SUBJECT: ISSUANCE OF AMENDMENT NO. 29 TO FACILITY OPERATING LICENSE  
NO. NPF-41, AMENDMENT NO. 16 TO FACILITY OPERATING LICENSE  
NO. NPF-51, AND AMENDMENT NO. 4 TO FACILITY OPERATING LICENSE  
NO. NPF-74, FOR THE PALO VERDE NUCLEAR GENERATING STATION, UNITS  
1, 2 AND 3, RESPECTIVELY, (TAC NOS. 66798, 66799 AND 66800)

The Amendments revise Section 6 of the Technical Specifications for each of the three Palo Verde Units to incorporate changes reflecting a revised organizational structure for the Palo Verde plant.

SAFETY EVALUATION BY THE OFFICE OF NUCLEAR REACTOR REGULATION  
RELATED TO AMENDMENT NO. 29 TO FACILITY OPERATING LICENSE NO. NPF-41,  
AMENDMENT NO. 16 TO FACILITY OPERATING LICENSE NO. NPF-51  
AND AMENDMENT NO. 4 TO FACILITY OPERATING LICENSE NO. NPF-74  
ARIZONA PUBLIC SERVICE COMPANY, ET AL.  
PALO VERDE NUCLEAR GENERATING STATION, UNIT NOS. 1, 2 AND 3  
DOCKET NOS. STN 50-528, STN 50-529 AND STN 50-530

OFFSITE ORGANIZATION  
Figure 6.2-1

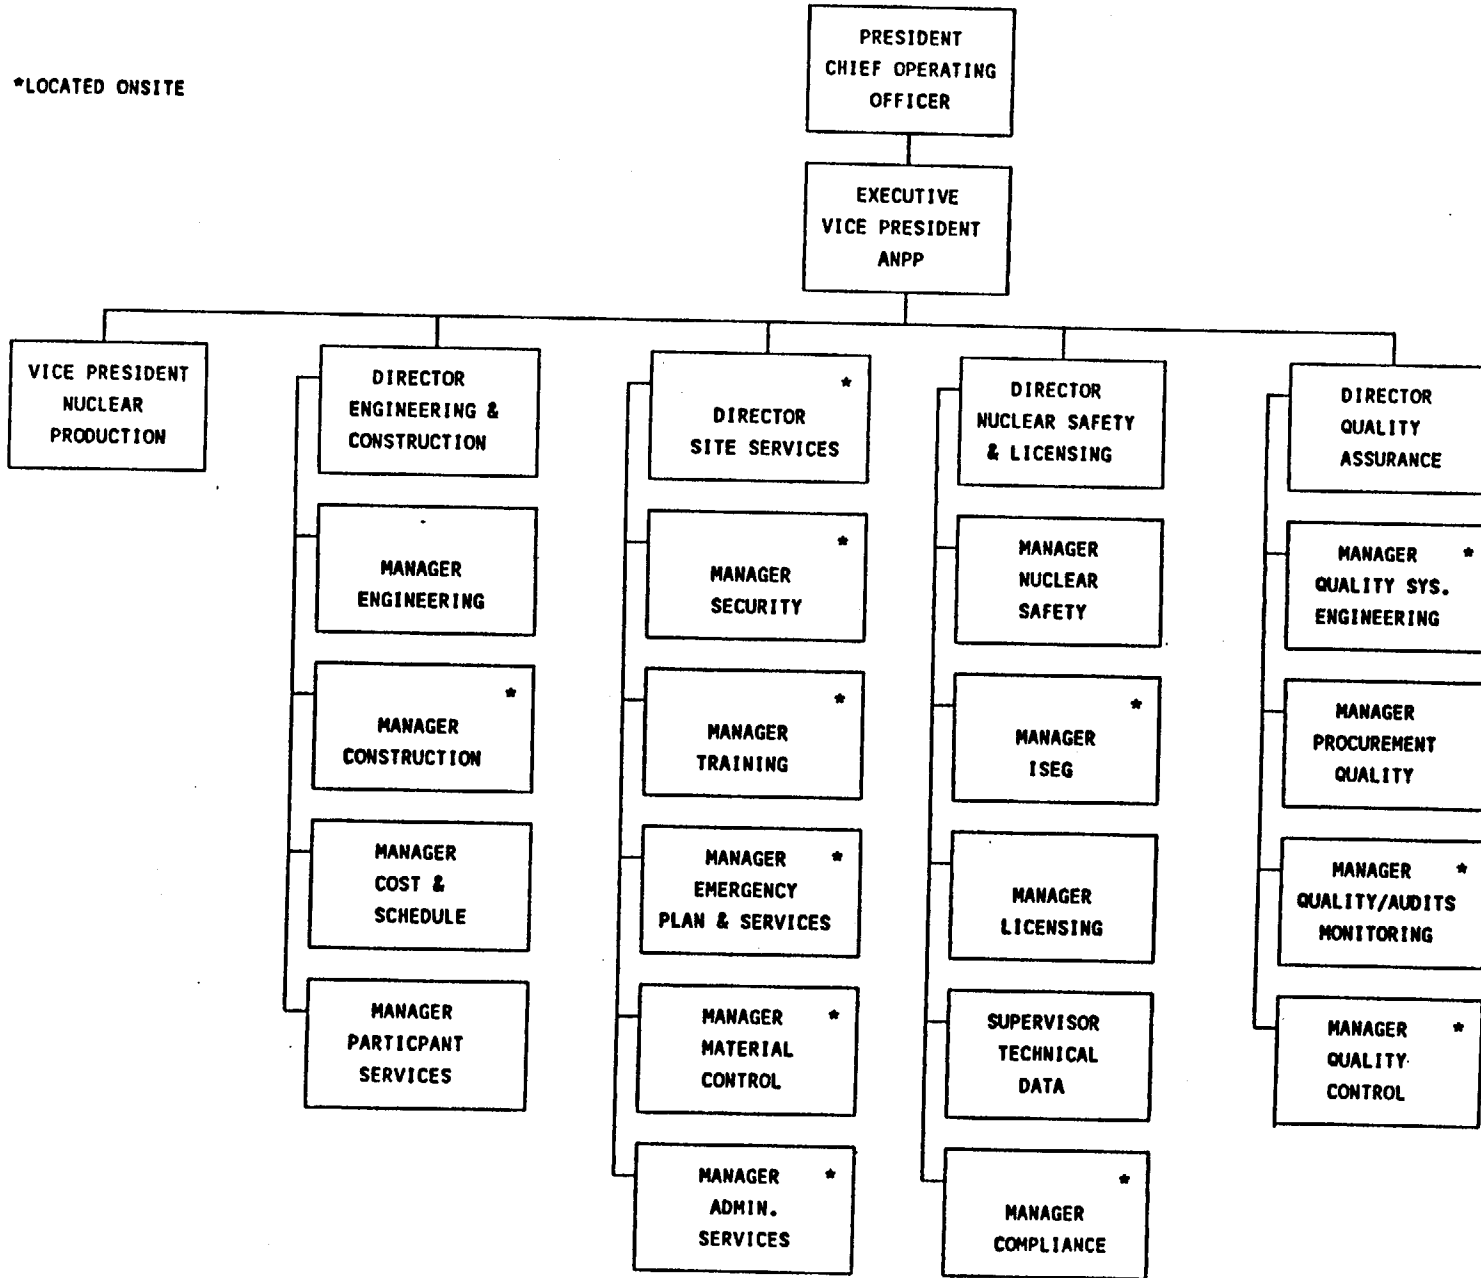
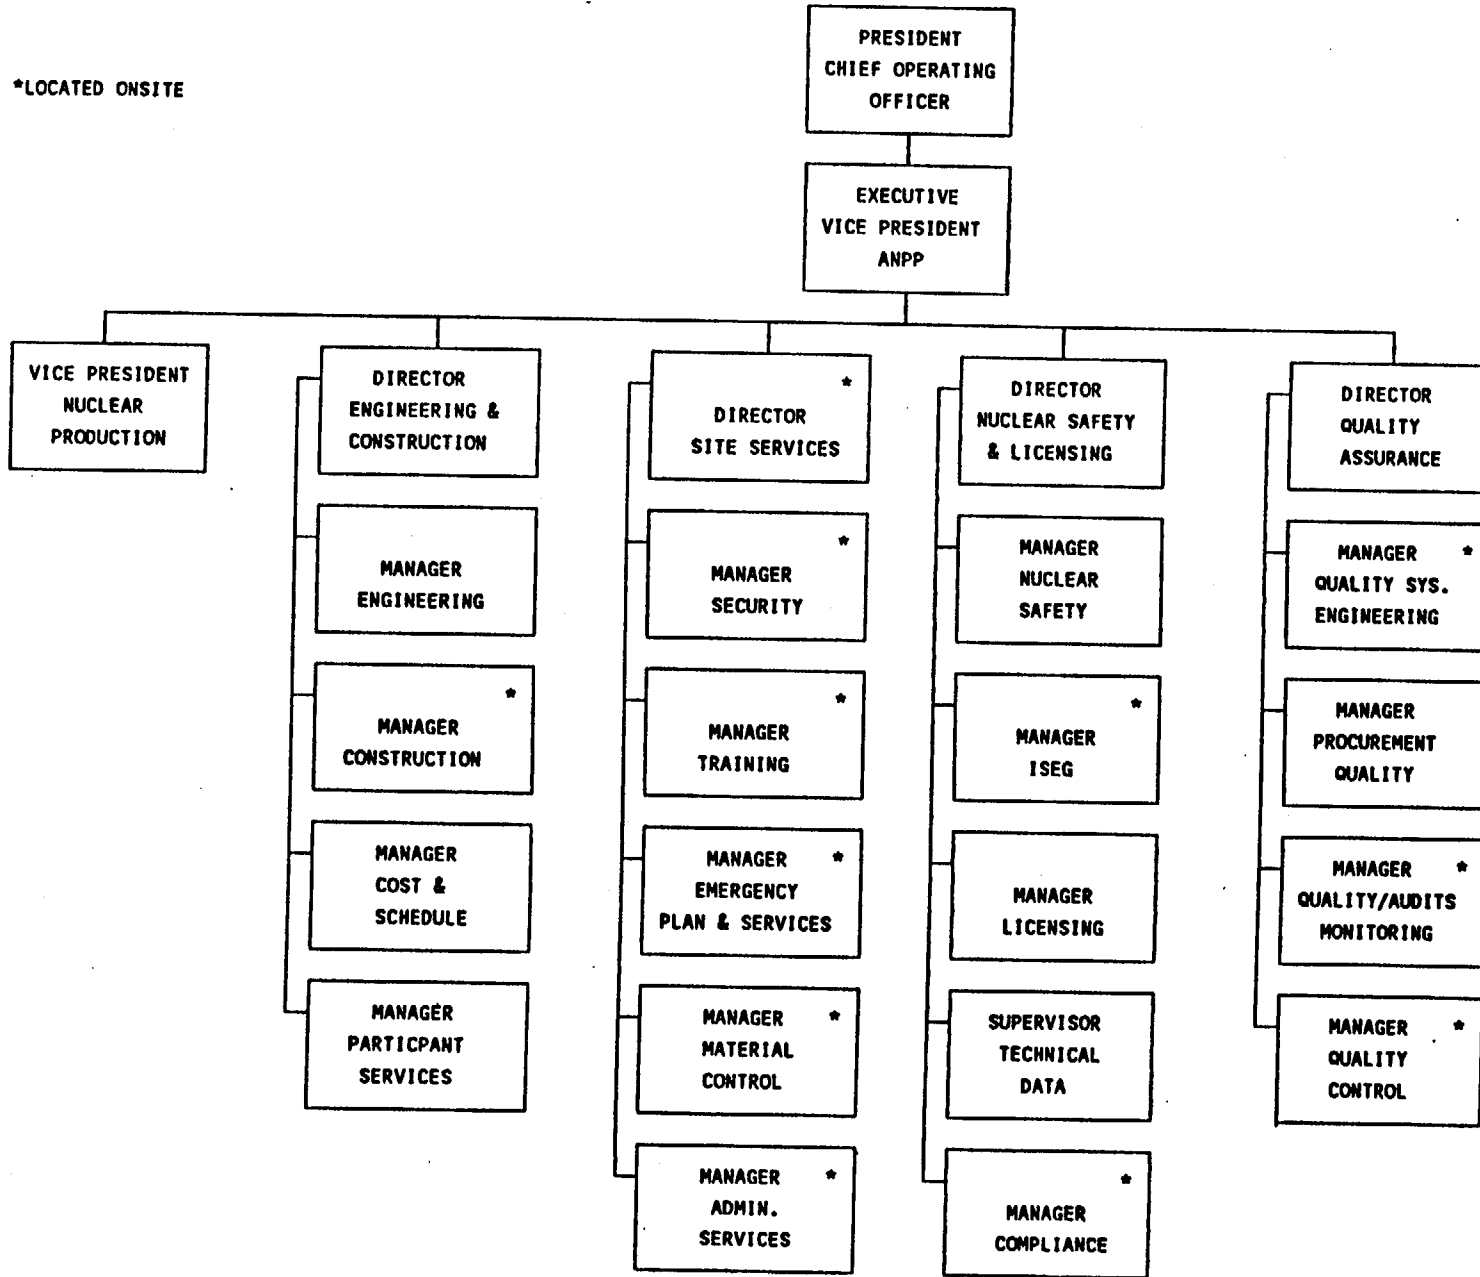
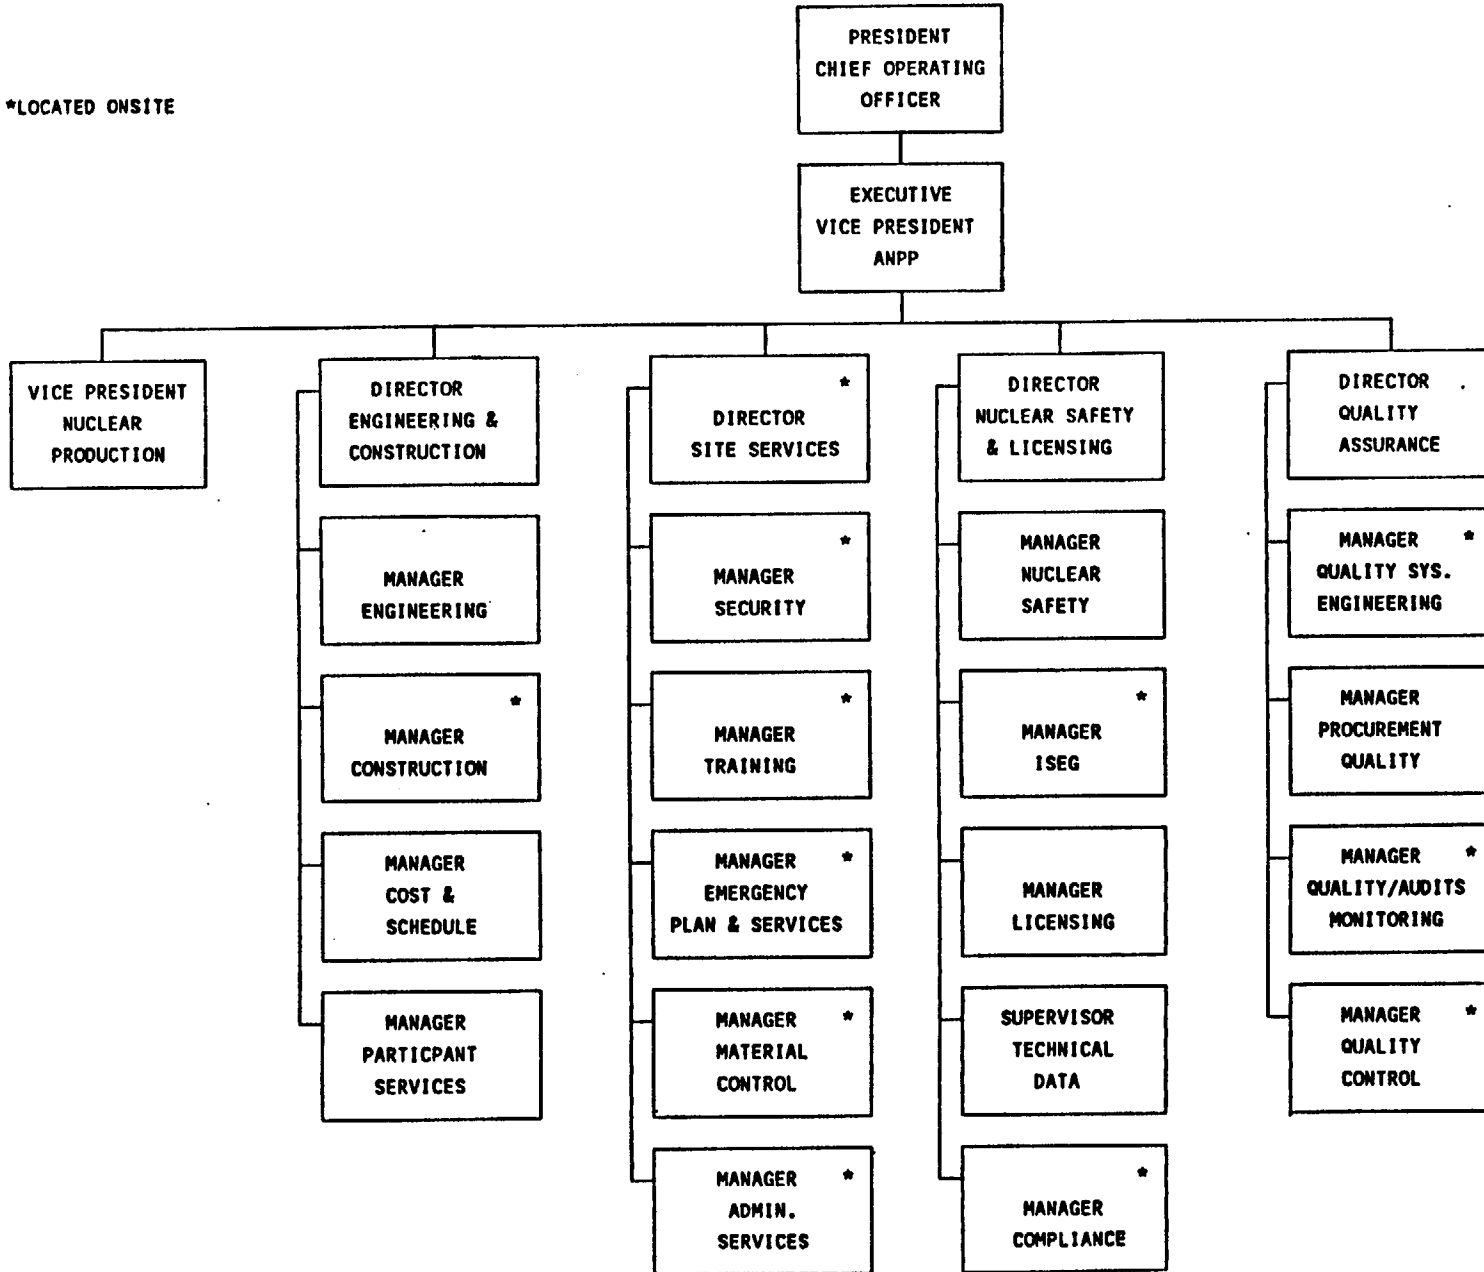
The proposed change requests an amendment to the Palo Verde Units 1, 2 and 3 Technical Specifications, Section 6, Figures 6.2-1 and 6.2-2, "Offsite Organization" and "Onsite Unit Organization." The change is administrative in nature in that the Manager of Nuclear Fuels will now report to the Vice President of Nuclear Production in lieu of reporting to the Director of Engineering and Construction. The change is intended to facilitate communications between the management of the Arizona Nuclear Power Project and the nuclear fuel supply vendor.
